Project #19-012
L59
Located at approximately 150 S. 100 E.

Project Name: L59
Proponent / Owner: Beth Larchar / DC1 Logan LLC (Trent Cragun)
Project Address: 150 S. 100 E.
Request: Design Review Permit & Rezone
Current Zoning: TC1, REC & NR6
Type of Action: Quasi-Judicial & Legislative
Hearing Date: April 25, 2019
Submitted By: Russ Holley, Senior Planner

RECOMMENDATION

C-101

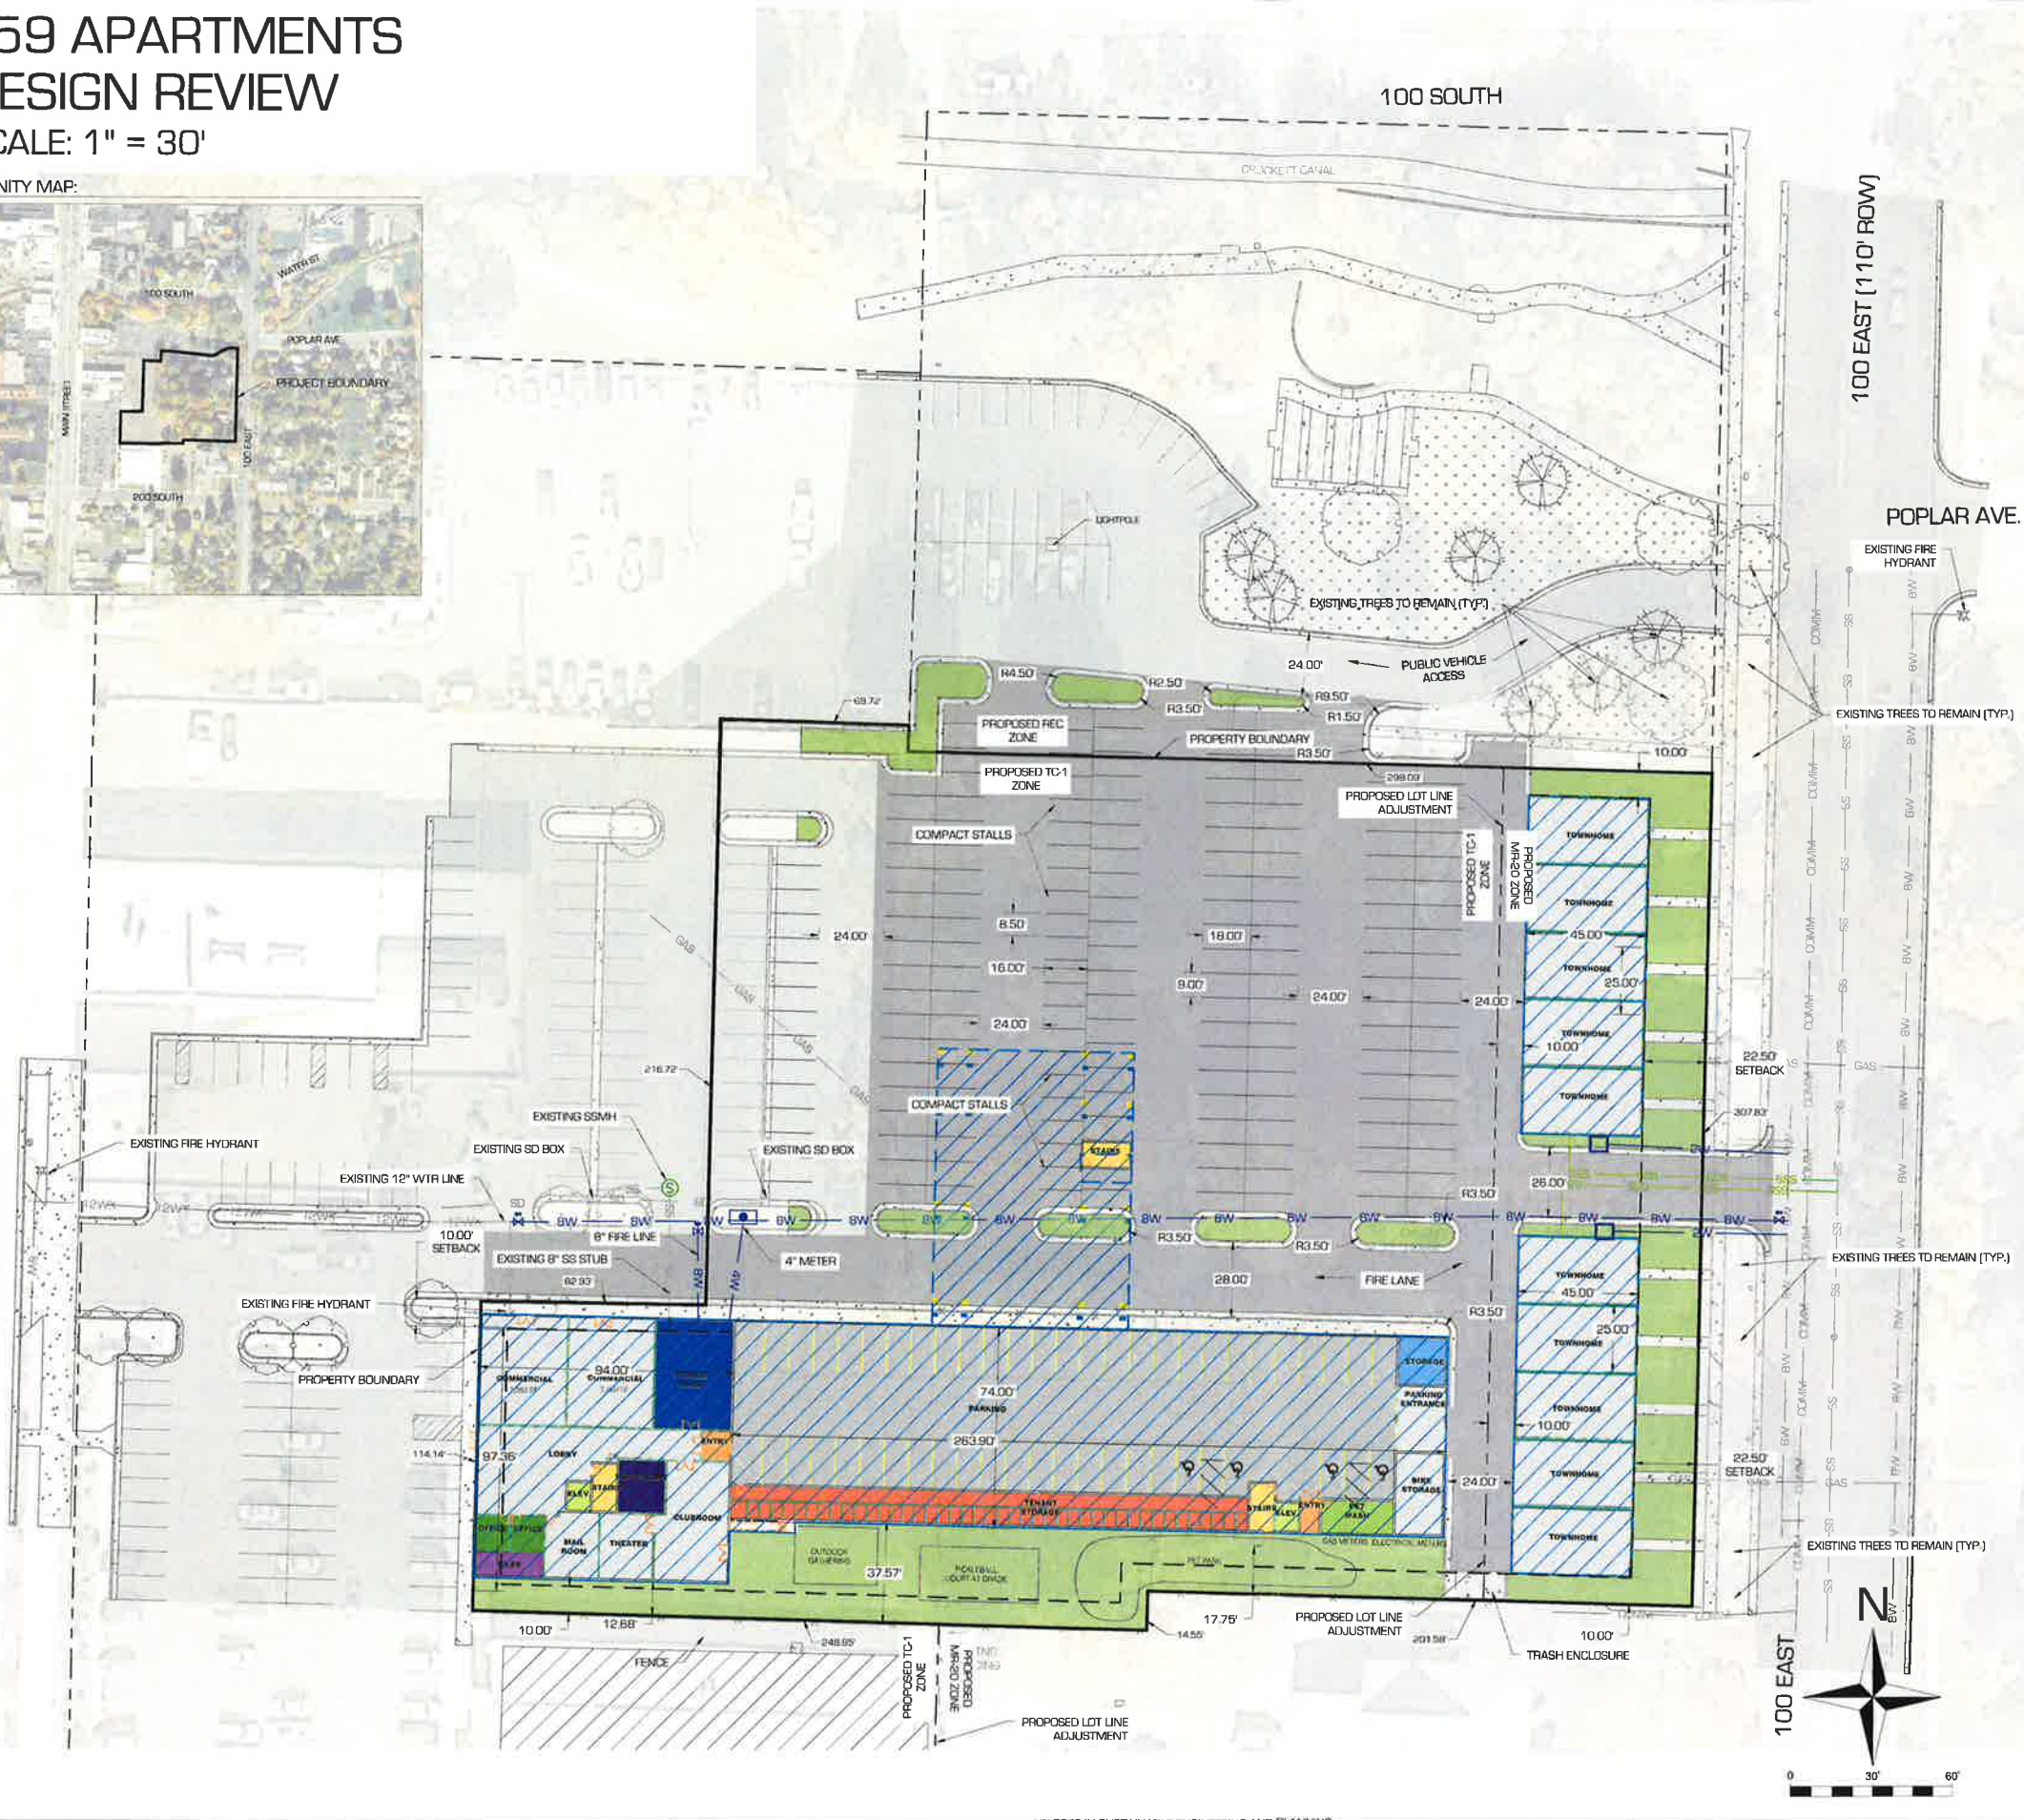
As proposed, the project does not meet the front minimum setback requirement for the townhome structures. Building code and fire safety code restrict buildings with openings not along a public right-of-way to be fire protected/rated or setback. As conditioned with building code considerations and the Planning Commission contemplating a reduction in the front yard setback adjacent to NR zoning, the project complies with setbacks in the LDC.

The proposed townhomes all have pedestrian connections from the building(s) to the street (100 East). The proposed TC-1 building does not show pedestrian connections to the street and throughout the project site. As conditioned with pedestrian connectivity throughout the TC-1 area, the project meets the requirements in the LDC.

5. A relative direct pedestrian (sidewalk) connection shall be made between the TC-1 building and sidewalks along the street and throughout the project site for better walkability.

AS101

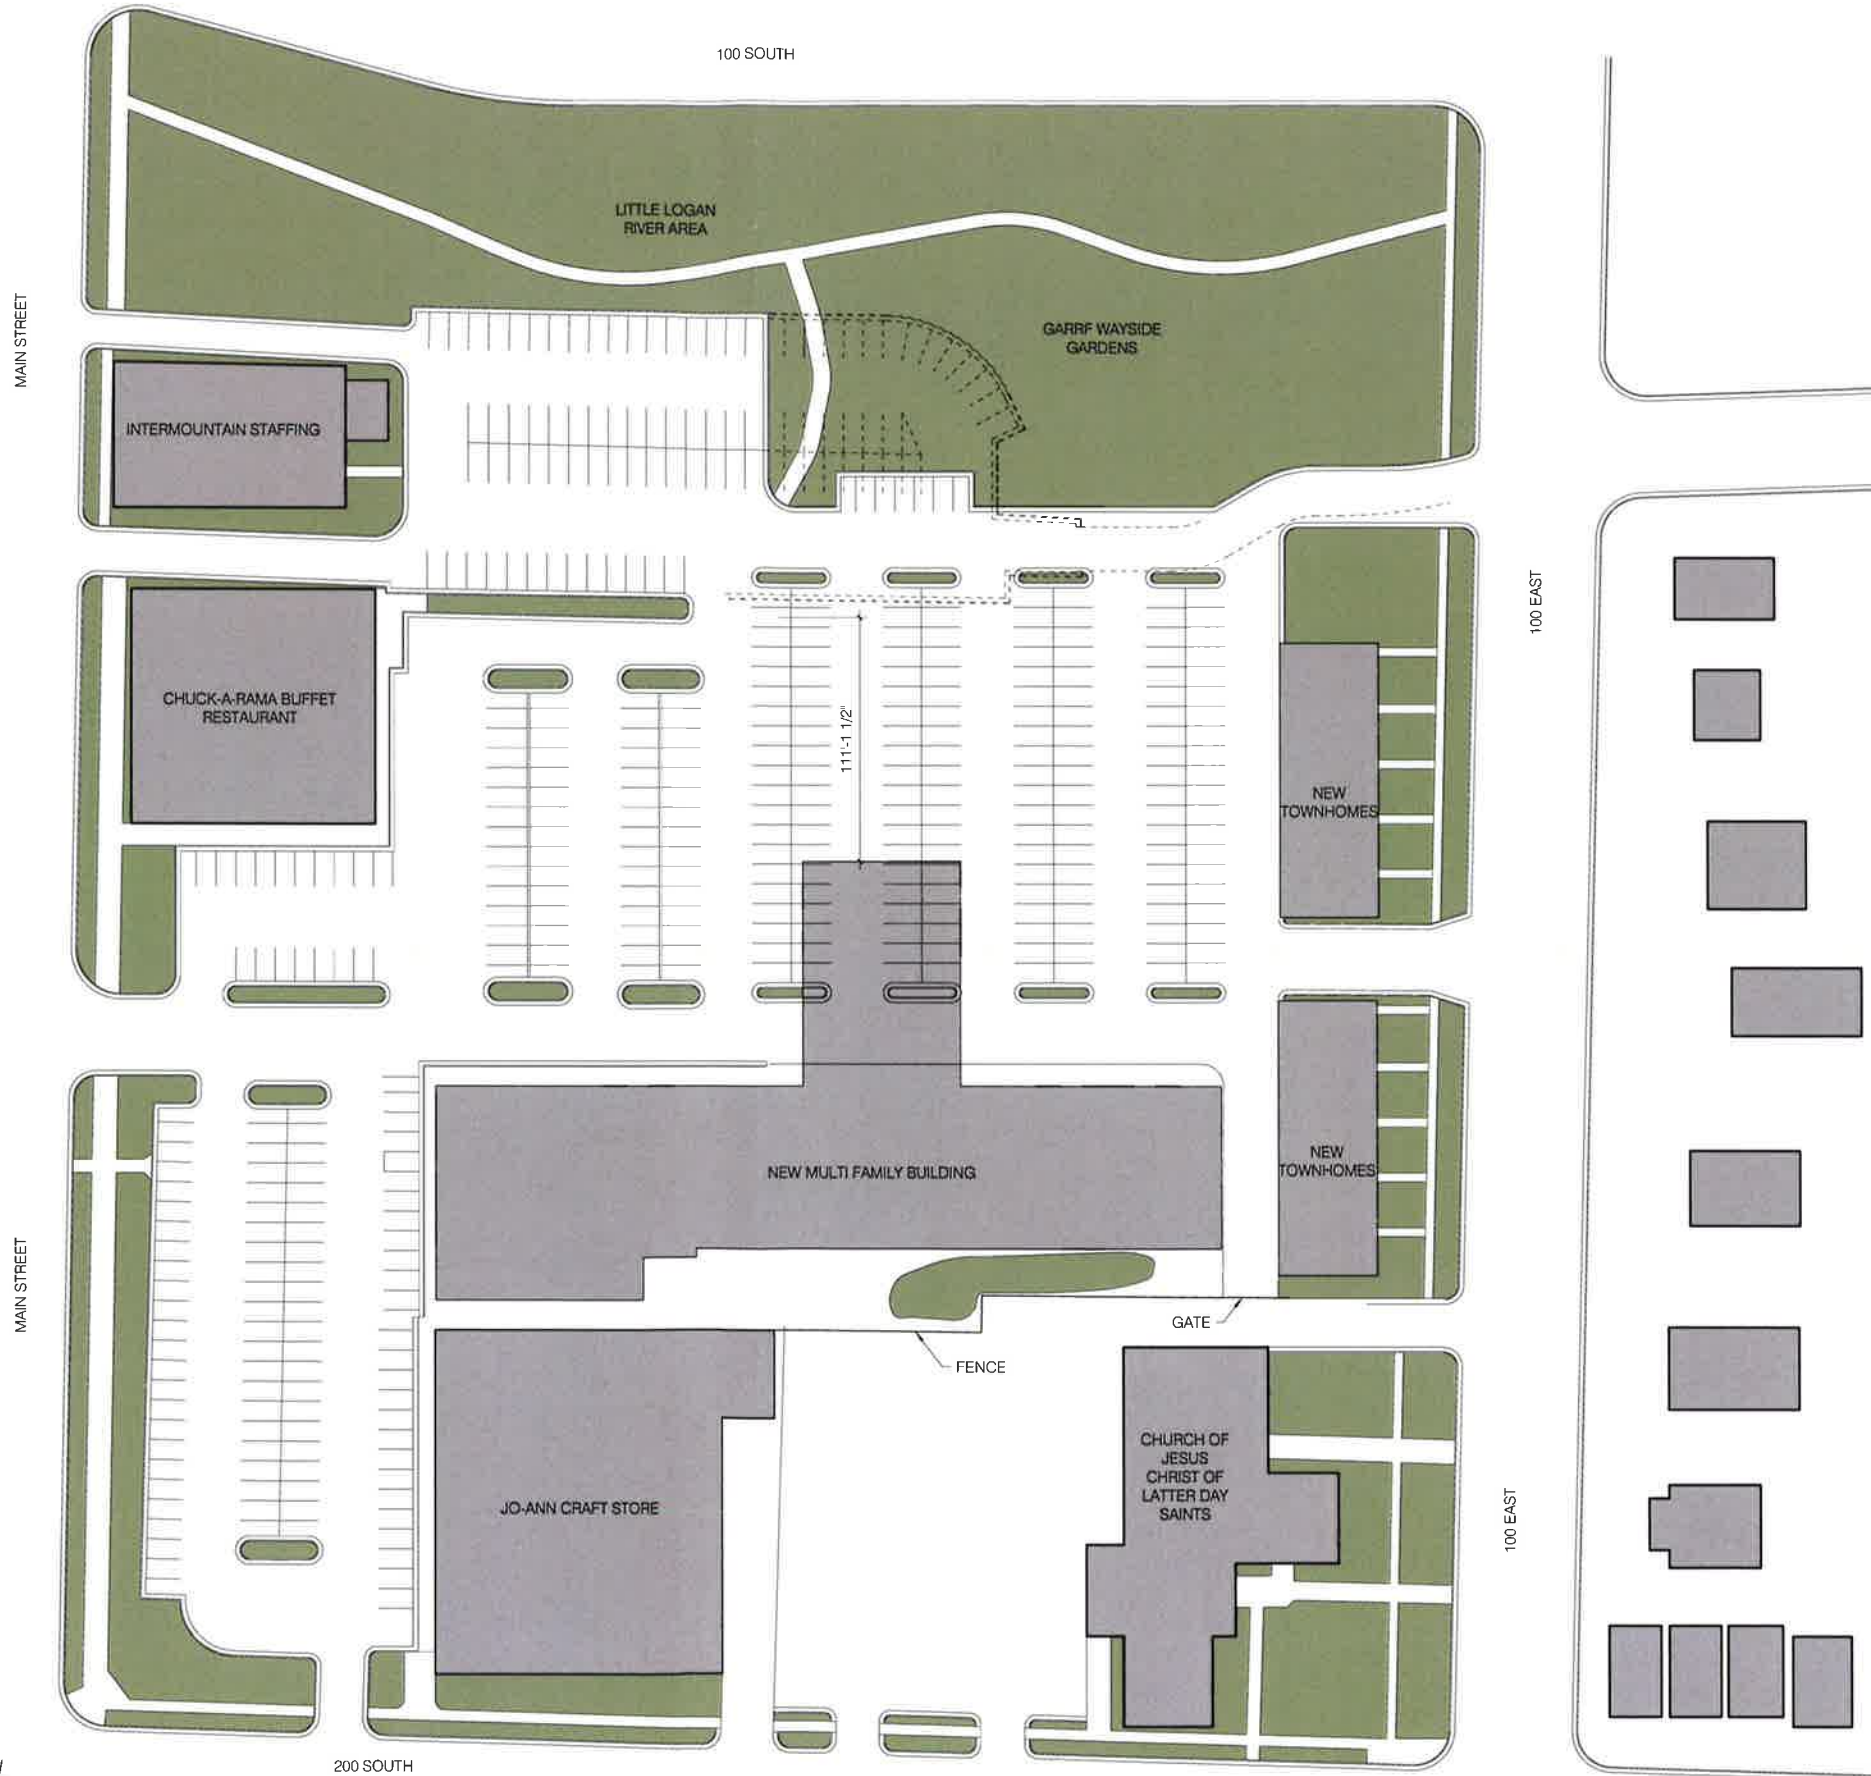
The LDC 17.09.010 states that parking lots be positioned to the side and rear of the building. Direct and delineated pedestrian connectivity shall be made from every building to the surrounding streets and throughout the site for overall pedestrian connectivity and better walkability. The parking lots are behind or to the side of the townhomes along 100 East. Along Main Street, a parking lot is shown/existing in front of the TC-1 building but the applicant does not fully control this existing parking lot property and it is not considered in the Design Review Permit. At a future time, this property may develop and would have a site layout that would match the rest of downtown and the TC-1 zone.

The proposed 15 parking stalls located adjacent to the site and restricted from overnight parking should not be used for general residential uses, however; fulfilling a visitor parking requirement is debatable. Visitors for this project could be both short-term and overnight stays. Staff would consider that it's likely that the 5 out of 20 required visitor parking stalls would not be overnight visitors and could be satisfied in the adjacent shared daytime parking lot. Ultimately, the Planning Commission will need to determine this judgment call.
